P 32461
A Repair

SEWAGE DISPOSAL SYSTEM MARYLAND STATE DEPARTMENT OF HEALTH

Jenkins Brothers IS PERMITTED TO INSTALL _____ ALTER X
ADDRESS 10439 Frederick Road, Ellicott City, Md. 21043 PHONE 465-8646

PROPERTY OWNER Mr. Joe Putgenter
ADDRESS 5233 Kerger Road, Ellicott City, Md. 21043 Phone: 744-5867

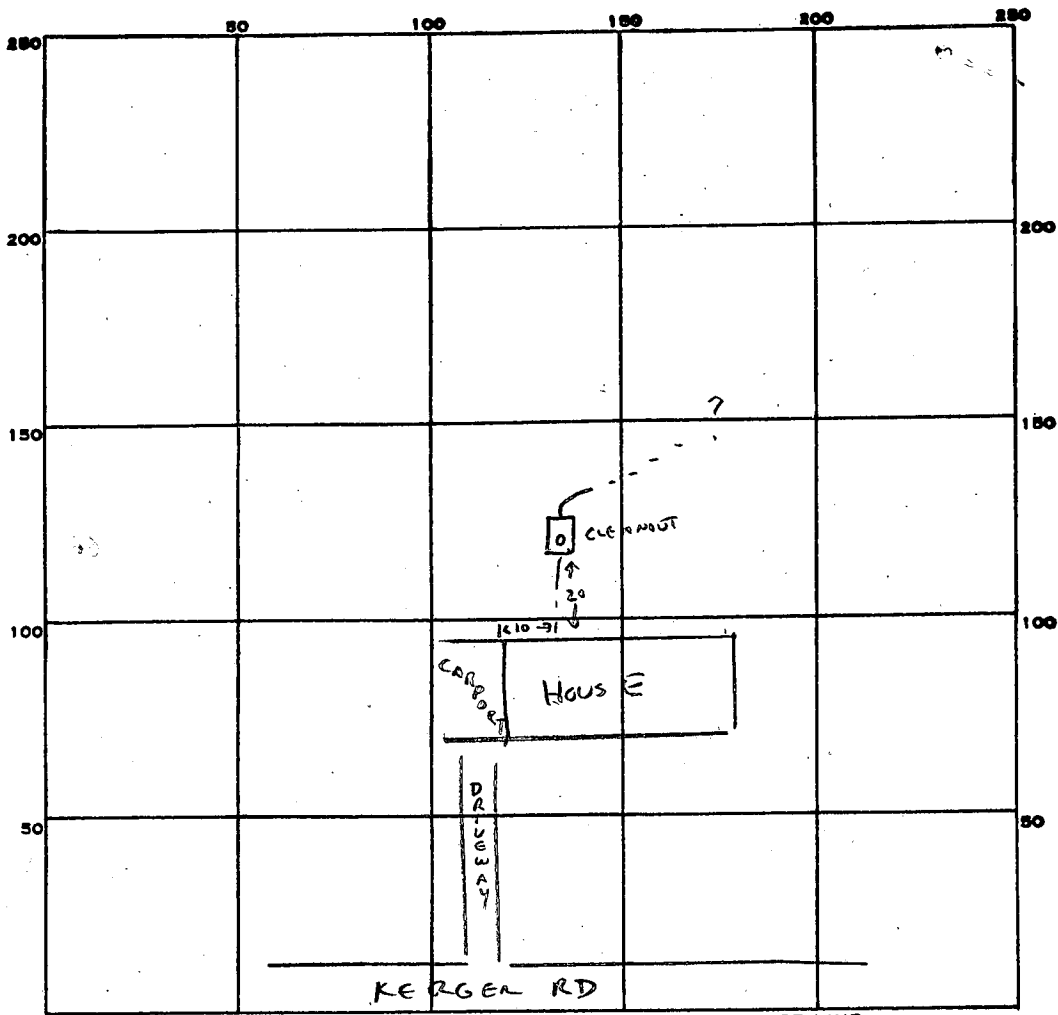
REPAIR - Call for an appointment when ground is opened up and Sanitarian will recommend the repair area.

REPLACE STEEL SEPTIC TANK WITH CONCRETE TANK.
2-8-83 C. Williams

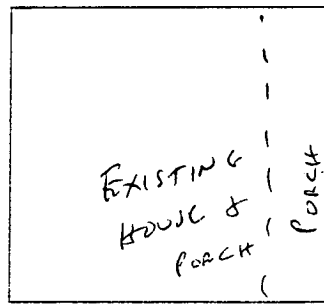
REMARKS INSTALLED REPLACEMENT SEPTIC TANK.

RUNNING
WATER TEST - NO EVIDENCE OF CLOGGING OR OVERFLOW IN DIRECTION
OF DISPOSAL AREA.

BRING CLEANOUT UP TO GRADE. 2-8-83 C. William

PLOT PLAN Lots 9+10
scale: 1" = 50'

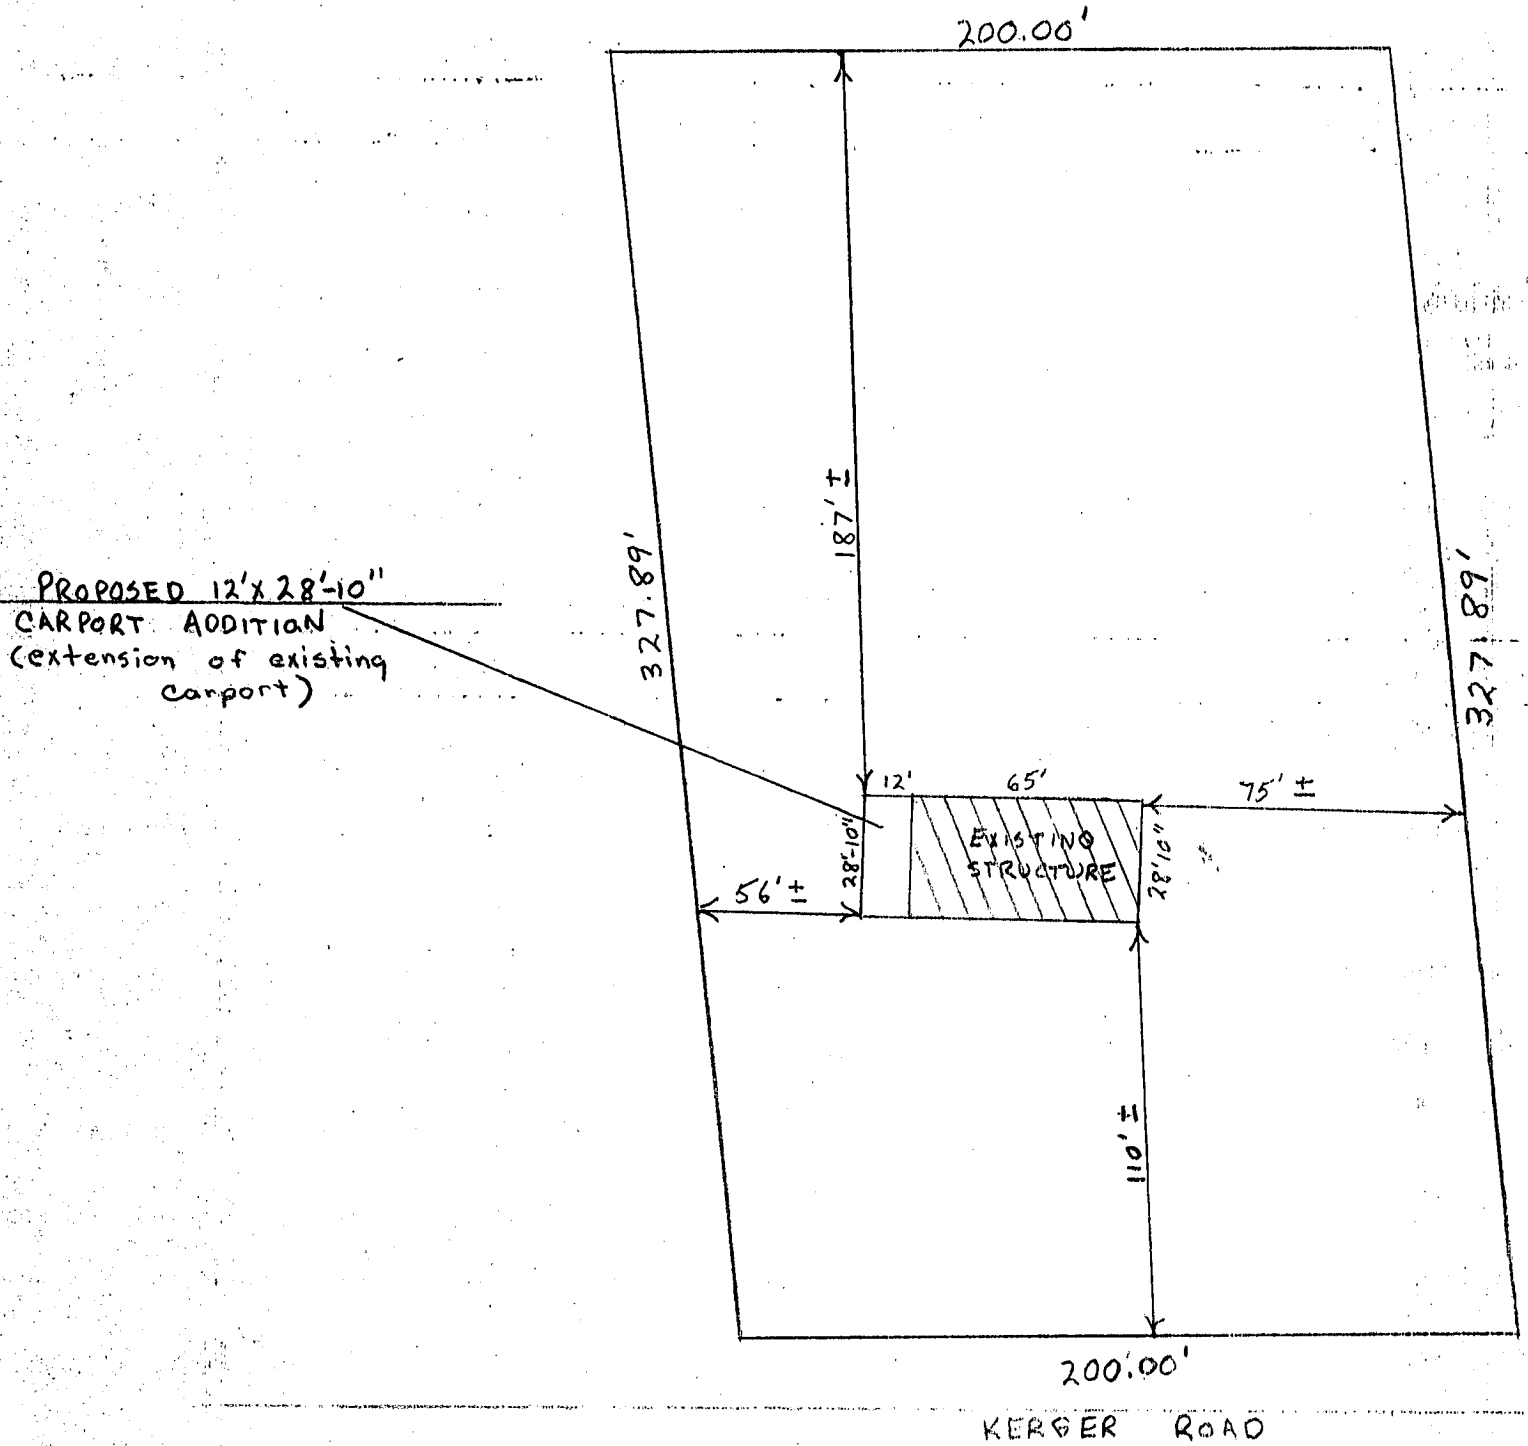
NO IMPACT
ON WELL OR SEPTIC
12/23/85 CWL
